UNITED STATES
DEPARTMENT OF THE INTERIOR
BUREAU OF LAND MANAGEMENTOCCUPANCY
ARTESIA DISTRICTFORM APPROVED
OMB NO. 1004-0137
Expires: January 31, 2018**SUNDRY NOTICES AND REPORTS ON WELLS**
Do not use this form for proposals to drill or to re-enter an abandoned well. Use form 3160-3 (APD) for such proposals.

RKI EXPLORATION & PRODUCTION RESPECTFULLY REQUESTS TO P&A THE ABOVE MENTIONED WELL.
THE WBD AND PROCESS ARE ATTACHED.

Federal G Gas Com #1
Current WB

Federal G Gas Com #1 Plug and Abandon Procedure

**Federal G Gas Com #1
Proposed WB**

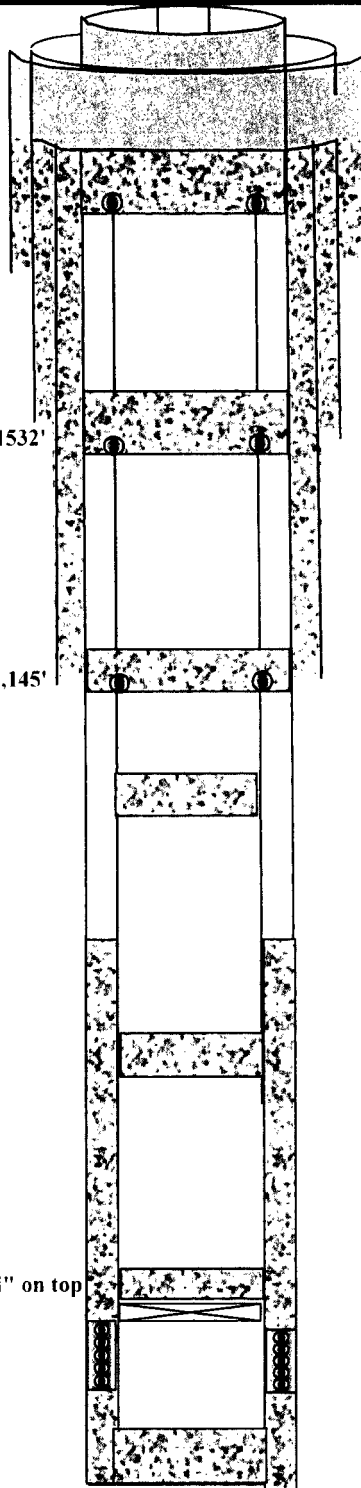
cmt'd w- 700 sxs. *TOC?*

NE Carlsbad on Potash Mines Road *Est. Actual*

7/5/14 480 524

Tonsil 1450 1668

Yates 1770 1773

2 3/8" tbg. to 10,759' *72 2054*

Cap: 40 2340 2288
3866

Del 3950

10984.96 502 other
Strawn: 10,973' - 11,042' ✓

11,742 - 12,134
Morrow: 11,922' - 12,324' ✓

CIBP @
11660
+55' cmt

- 7) POOH & LD tbg. to 8,822'. *9880 - 9680 (Top Wolfcamp)*
- 8) Spot 30 sxs. Class "H" cmt. from 8,822' - 8,600'. *9880 - 9680*
- 9) POOH w- tbg. to 5,600'. *6560*

- 10) Spot 30 sxs Class "C" cmt. from 5,600' - 5,400'. *Perf @ 6560, 582 cmt to 6400.000 Tag (Top Bone Spring)*
- 11) RU WL & Perforate 4 holes @ 4,295'. RD wireline.

- 14) RU WL & Perforate 4 holes @ 4,682'. RD wireline. *3716 (Base Capitan)*
- 15) RIH w- Pkr & tbg. - set Pkr - Establish injection rate. Squeeze 60 sx Class C Cement (14.8 ppg, 6.3 gps, 1.32 cfs yield) from 4,682' to 4,532'. *502 cmt from 3716 - 474 (R-111-A solid plug)*

- 16) WOC & Tag @ 4,532'. *474 OK to circ. to surf. Multiple stages.*
- 17) RU WL - Perf @ 420' - *420*
- 18) RIH w- Pkr & tbg. - set Pkr - Establish injection rate. Squeeze 130 sx Class C Cement (14.8 ppg, 6.3 gps, 1.32 cfs yield) from 400' to surface.
